RE: DA-2279-00 – King Soopers Fuel + Wells Fargo Drive-Thru ATM – Conditional Uses and Site Plan – 2nd Comment Responses

King Soopers Fuel #30 – Havana & Idaho
Aurora, Colorado (2021-6031-00, -01, -02)
October 13, 2021

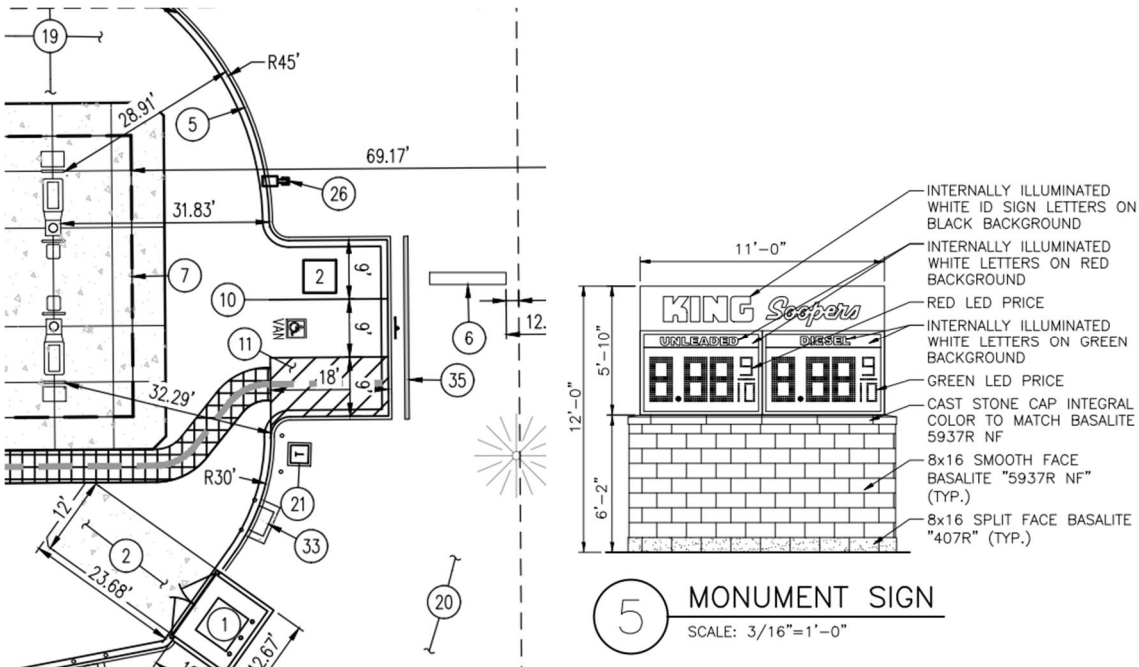
2E. Requesting an operations plan to be inserted into the introduction letter. An explanation of delivery times to understand potential traffic impacts on adjacent streets and neighborhoods as the trucks circulate.

RESPONSE:
